Service Bulletin

Date JANUARY 1984
Sheet 1 of 9
Bulletin JD.01/84

60. LOWER BALL JOINT SECURING BOLTS

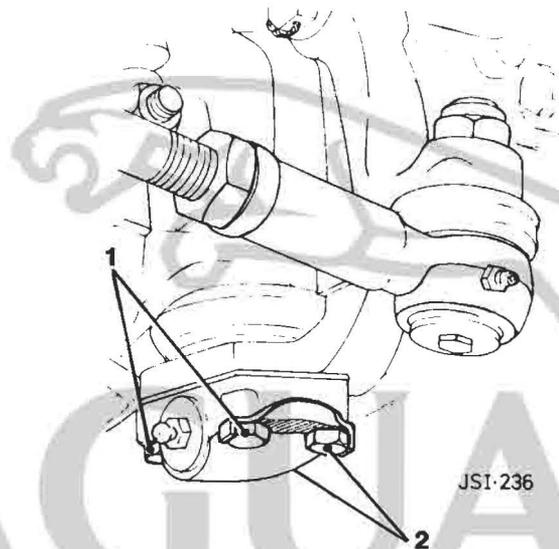
It is important that if any of these bolts are removed during service, they should be replaced in the correct position – see diagram.

1. Water ingress via bulkhead plenum chamber – Series III & XJ-S (Fig. 1)

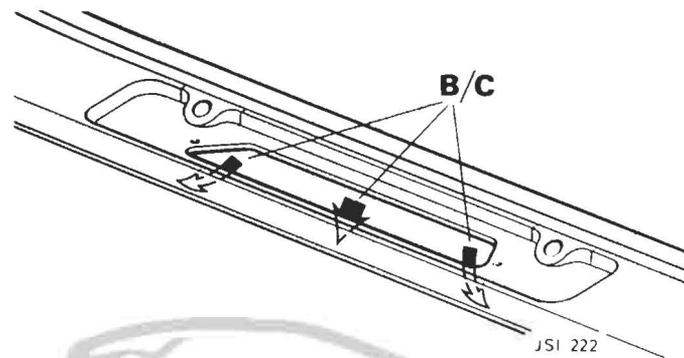
If the seams in this chamber are inadequately sealed, water can enter the vehicle footwells whenever the vehicle is exposed to heavy rainfall.

1. Remove plenum grille (Series III Workshop Manual Operation 80-15-29, XJ-S Workshop Manual Operation 84-15-12 – Items 1–7).
2. Apply sealant B or C by brush into all seams inside the chamber (Fig. 1).
3. Replace grille.

5. Water ingress drip channels – Series III & XJ-S

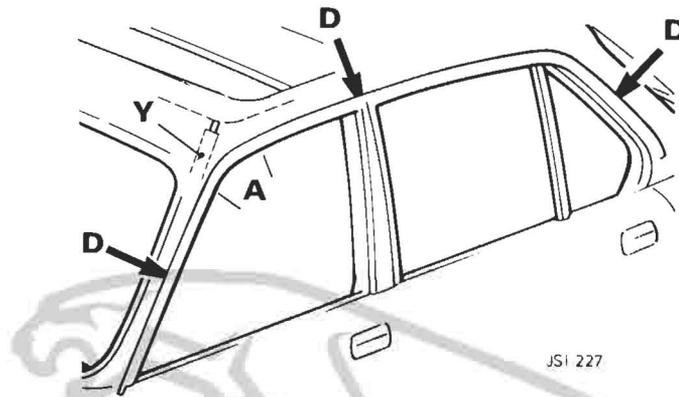
NOTE: Sunroof cars only – if after corrective action water is still entering the car at point "A", this may be due to a porous or badly fitted drain tube hose. This can be proved by partly opening the sunroof and pouring water into the drain outlet. If a fault exists, water will seep into the car as indicated.

- i. Remove drip rail finishers BAC 2480/2481/2482/2483 for access.
- ii. Apply sealant "D" by tube or brush along the seams of the drip channel (Fig. 5).

- A Remove headlining (Workshop Manual Operation 76-64-01). Leave in car but remove to allow access to forward sunroof drain tubes.
- B Identify fault, i.e. badly fitted or split hose, at point "Y" (Fig. 5).
- C If the hose requires replacing, remove front wheel arch rear stone guard.
- D Feed a length of wire down the drain tube so that it protrudes from the wheel arch.
- E Pull out the faulty hose, leaving the wire in position.

6. Water ingress via seams at "A" post waist – Series III

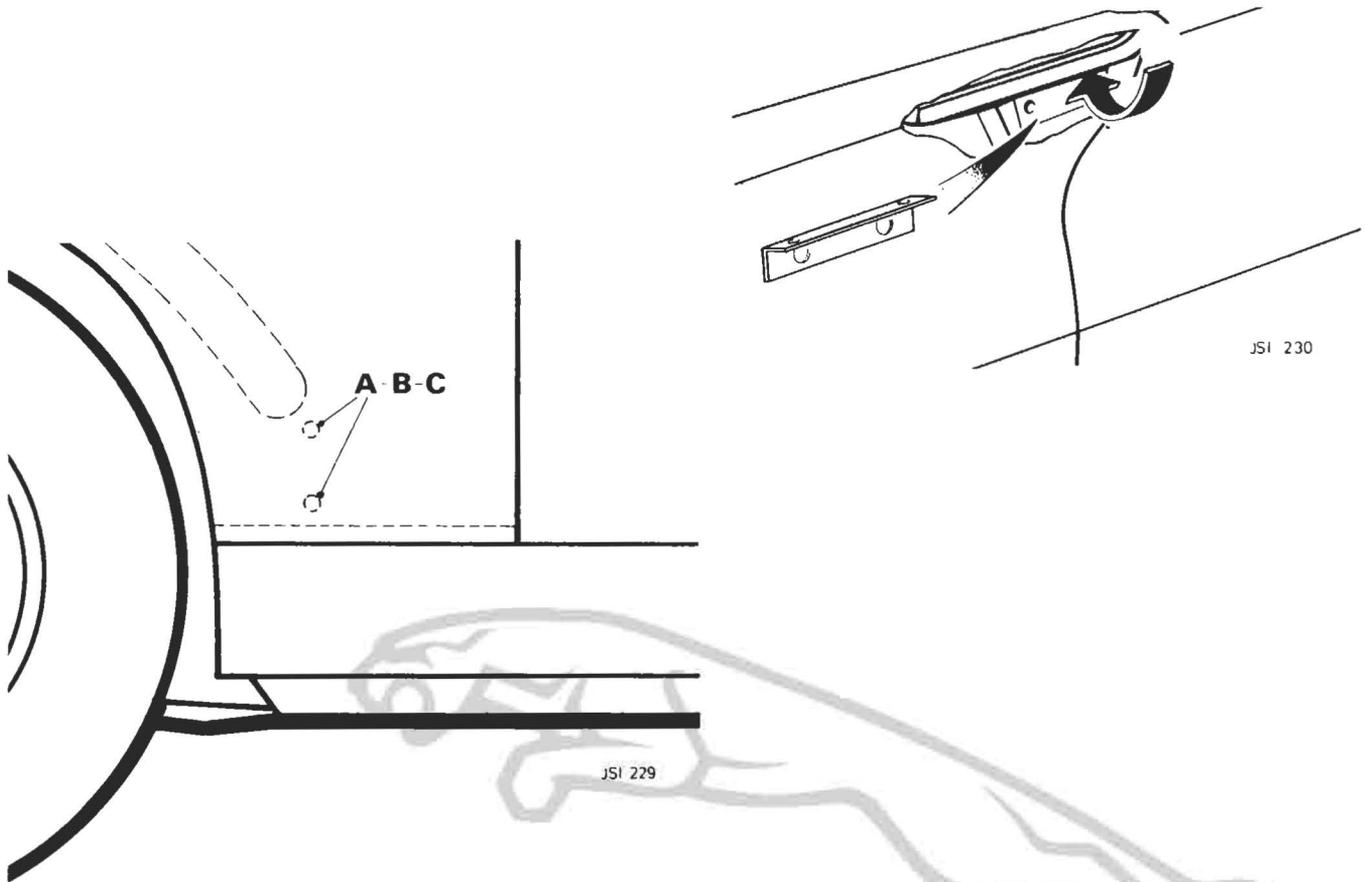
This problem may occur if there is an open seam at the base of the drip rail which allows water to enter the car interior via the "A" post box section.

- A Remove the "A" post draught welt.
- B Remove trim from footwell at base of "A" post (BD 43251 – RH, BD 43252 – LH, BAC 9906 – RH VDP, BAC 9907 – LH VDP).
- C Examine interior of the box section whilst water is "poured" down drip rails.
- D Refer to Fig. 6A and 6B for possible leak areas, and rectify using one of the following methods:
 - i. Leakage from point 6A – remove front wheel arch stone guard and apply sealant "A", "B", or "C".
 - ii. Leakage from point 6B – remove front wing (Workshop Manual Operation 77-28-29) and apply sealant "A", "B", or "C".

11. Water ingress via windscreens – Series III only (Fig. 11)

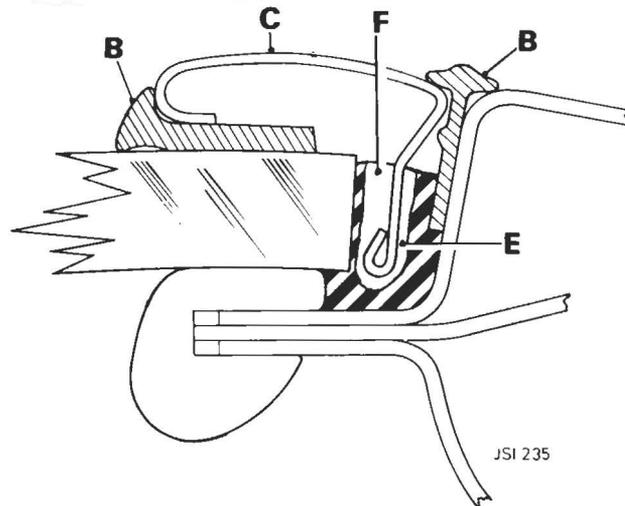
This complaint is caused by poor adhesion of Betaseal to screen and/or aperture.

Major repair of this fault is detailed in Service Bulletin JD 05/81 Item 35. However, local rectification of small leaks may be carried out using the following method:

- A Identify area of leakage
- B Remove inner and outer lace.
- C Remove the relevant bright finisher.
- D Carefully cut a section of Betaseal from the suspected leak area, prime and apply new Betaseal.

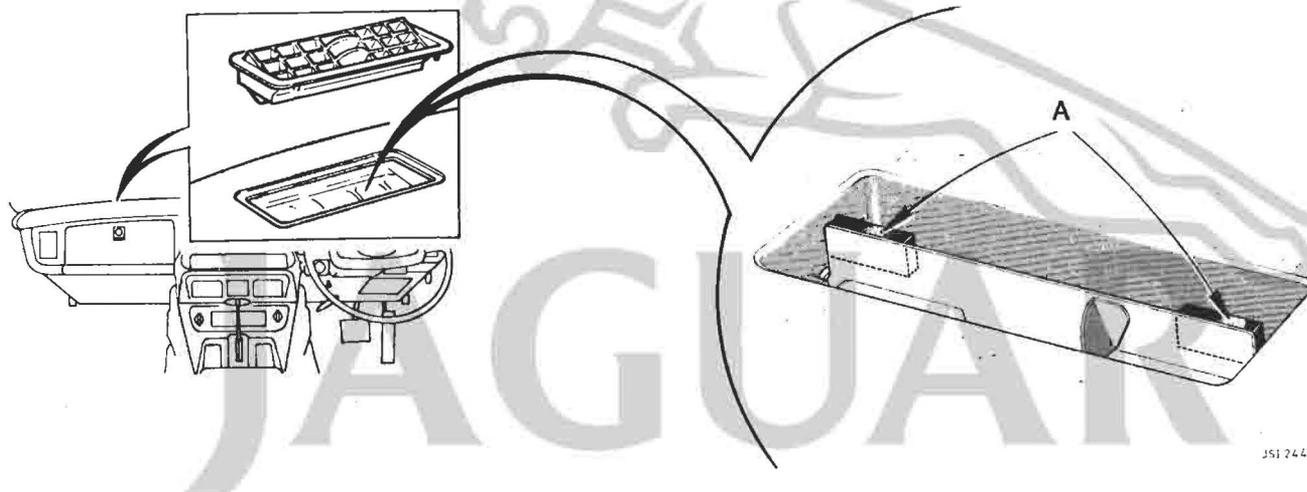
Investigations into screens misting on Series III Non Air Conditioned models, whilst the system is selected in positions other than defrost, have identified the cause to be insufficient air flow at the screen vent apertures. To overcome this problem, modified screen vent assemblies providing improved air flow distribution have been introduced at:

1. Carefully remove both screen vent aperture grilles from the facia crash roll.
2. Switch unit to defrost position to open screen vent flaps.
3. Use 4 off self adhesive rubber strips (not foam) to the dimensions detailed:

25mm long x 12mm wide x 6mm thick

37 MANUAL GEARBOX

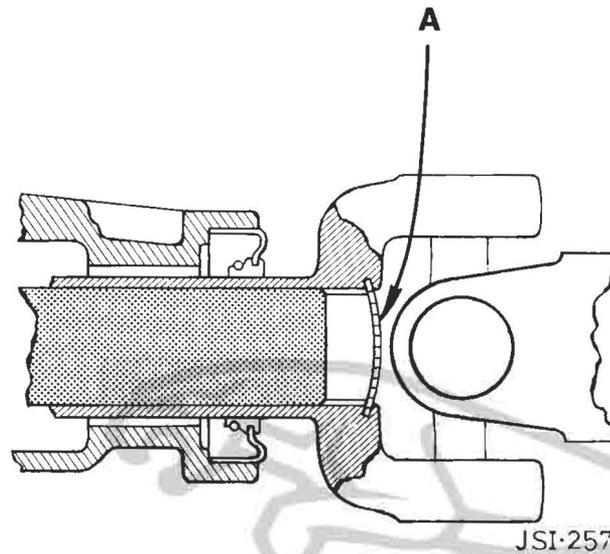
Several reports have been received of 77mm 5-speed gearboxes "jumping out of gear". Sample gearboxes returned for investigation have been tested and found to be functioning correctly. It is known that if the transmission tunnel cover plate or gear lever gaiter are incorrectly fitted, the gear lever movement can be restricted to prevent the gears engaging fully. If any manual XJ6 vehicles are encountered which are jumping out of gear or suffering difficult gear engagement, then the centre console should be removed to check that the gear lever movement is not restricted by either the gaiter or the cover plate before the transmission is removed.

FIG. 1

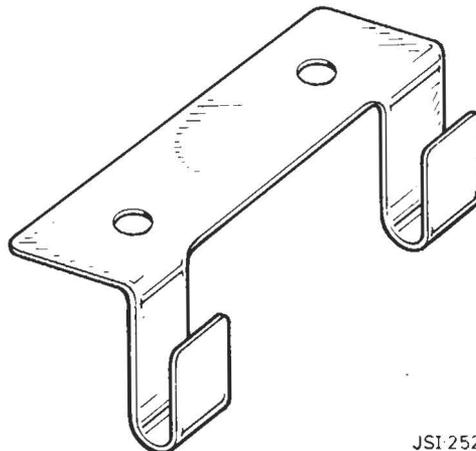
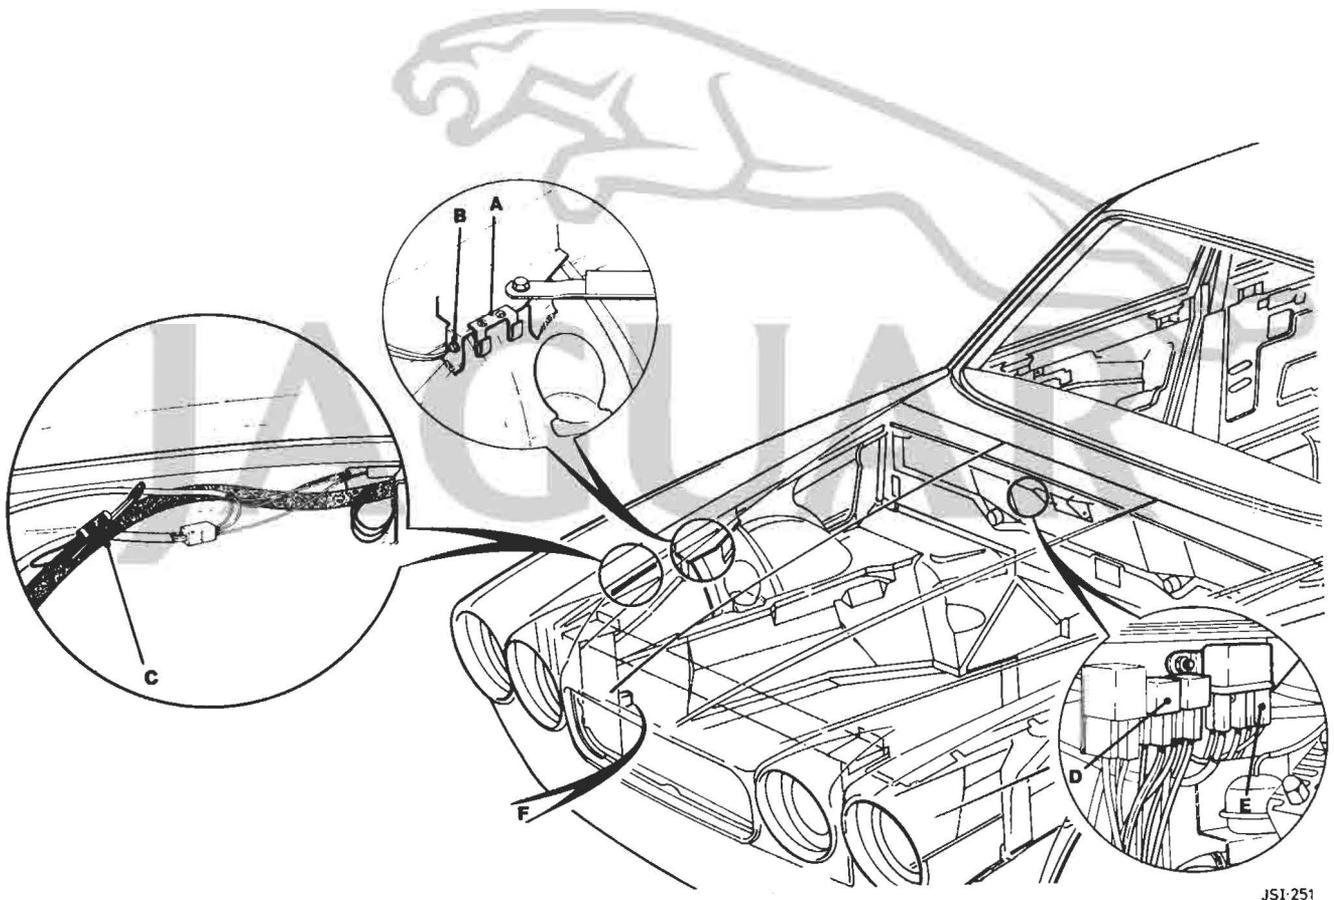
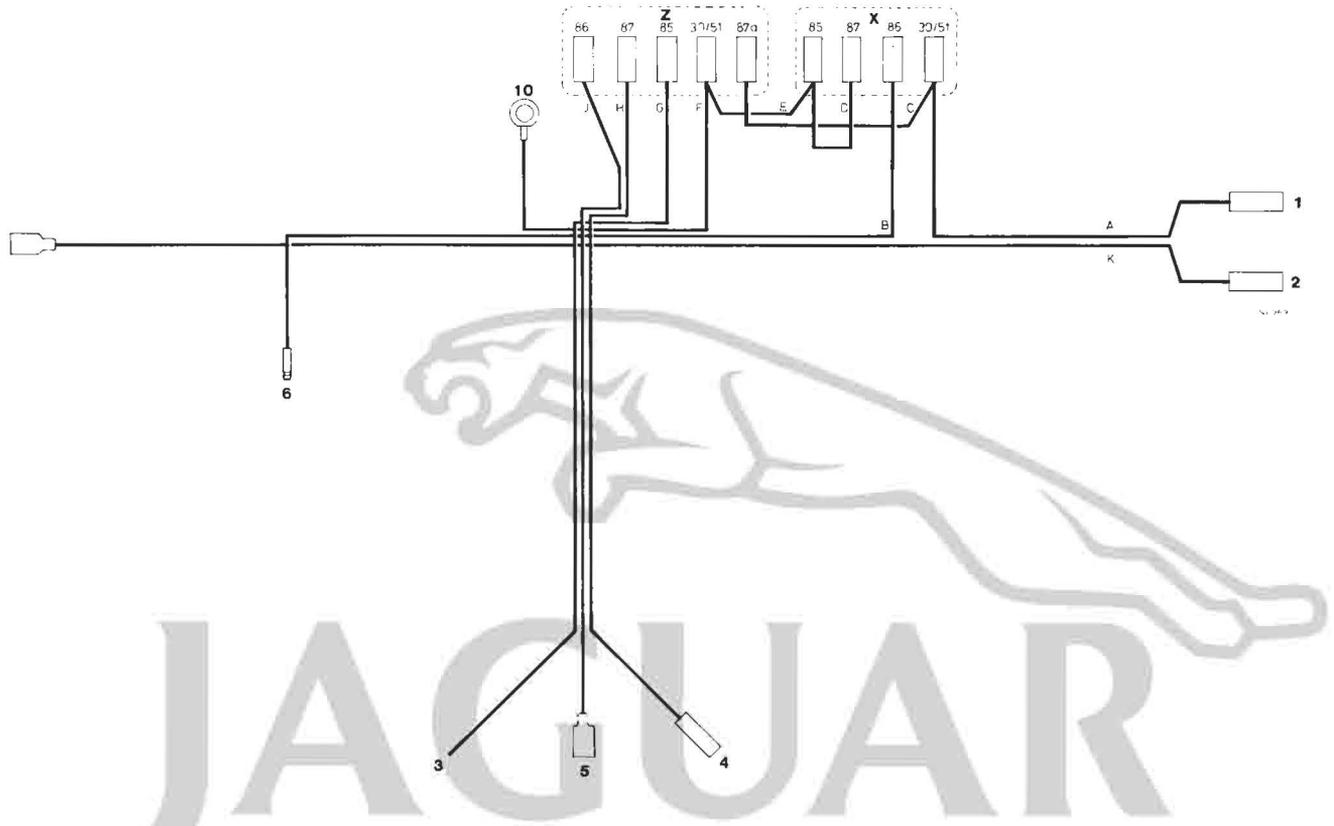
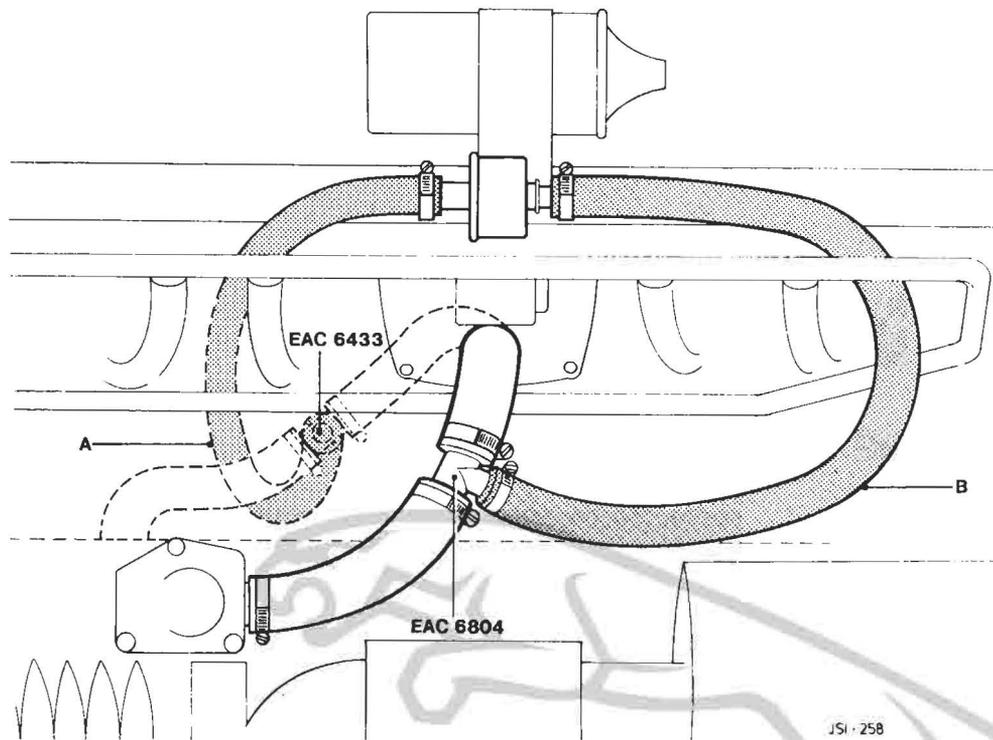
To overcome this complaint, a modification incorporating a supplementary air valve has been devised. This air valve will enable air to by-pass the auxiliary air valve, thus supplying extra air to compensate for the reduction in idle speed when the air conditioning compressor clutch engages or drive is selected.

1. Position relay mounting bracket (DAC 3124 D) in a vice with the legs protruding through the jaws. Bend legs back to an angle of 90 degrees (see Fig. 1).

2. Disconnect battery and remove air cleaner.
3. Position the bracket as shown in Fig. 2(A) and mark the position of the holes. Drill two 3mm (0.125in) diameter holes and secure the bracket using screws AB 610041 D.
4. Raise front of vehicle and place on axle stands or position vehicle on a ramp.
5. Remove the auxiliary air valve from the engine with both hoses still attached.
6. Remove 15mm (0.625in) length of hose from the centre of the valve to air distribution block hose and fit T piece EAC 6804 D (with restriction in small diameter pipe). Use hose clips EAC 3215/6 D but do not tighten clips at this stage.

- 1 & 2 Connect to supplementary air valve.
- 3 Remove connector block from main relay (D Fig. 2) situated on the bulk-head and using a suitable implement (e.g. a small electrical screwdriver), displace the white (W) cable lucar connector. Cut lucar off and discard, join cable to white cable of new harness (3 Fig. 3), attach lucar with retaining tang (Part No. JLM 310), and solder joint. Locate lucar in connector block and refit to main relay. Ensure that lucar retaining tang has locked.

- 4 & 5 Remove black/green (BG) cable from the starter relay (E Fig. 2), and attach green/red (GR 4 Fig. 3) to relay. Connect displaced black/green (GB) to green/black (GB) of new harness (5 Fig. 3).
- 6 Connect green/brown (GN) (6 Fig. 3) to green/brown (GN) compressor feed situated on the inner wing panel adjacent to the line splice (C Fig. 2).
- 7 Disconnect green (G) ignition feed from horn relay (F Fig. 2) and attach to piggy back connector (GHF 2420). Connect green cable (7 Fig. 3) to piggy back and refit to horn relay.
- 10 Attach ring eyelet to earth point (B Fig. 2).

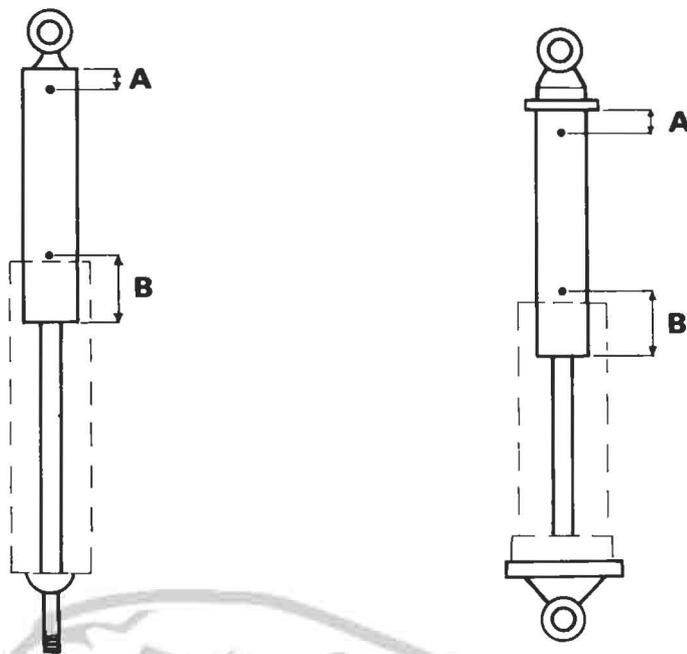
Following the introduction of Trico Series '10' wiper arms/blades, reference Service Bulletin JD 06/83 Item 44, and in particular the dimensions detailed regarding the wiper arm/blade setting procedure, further problems have been encountered with blade judder through the possibility of the drivers side blade fouling the screen finisher, resulting in the setting procedure being revised.

To ensure that windscreen wipers perform correctly, it is important that the new type arms/blades are fitted and positioned in accordance with the revised dimensions, see inset A.

FIG 1

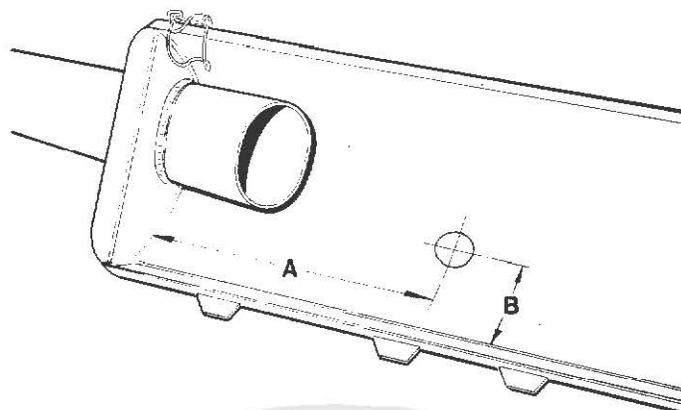
Isolated reports of air pump noise have been received which have been attributed to resonance caused by the air cleaner cover. Investigations have determined that this condition can be overcome by the addition of a 19 mm hole in the air cleaner cover opposite the air pump pick-up post in the backplate. Where this condition is experienced, vehicles may be modified in accordance with the procedure detailed below. Warranty claims should be submitted quoting Warranty Code 1 PCF and Repair Operation No. 19 91 15. A labour allowance of 0.2 hours may be claimed.

- * Remove the right hand air cleaner cover and place on a bench.
- * Mark the hole position to the dimensions shown in Fig 1 and drill a 3 mm pilot hole.

Dimensions	XJ12	XJS to VIN 148781	XJS from VIN 148782 (Teves Brakes)
A	90 mm	90 mm	175 mm
B	50 mm	50 mm	50 mm

- * Using a suitable hole-saw, cut a 19 mm dia. hole.
- * Carefully remove burrs and any swarf debris from the air cleaner cover.
- * Apply paint to the hole edge.
- * Refit the air cleaner cover.
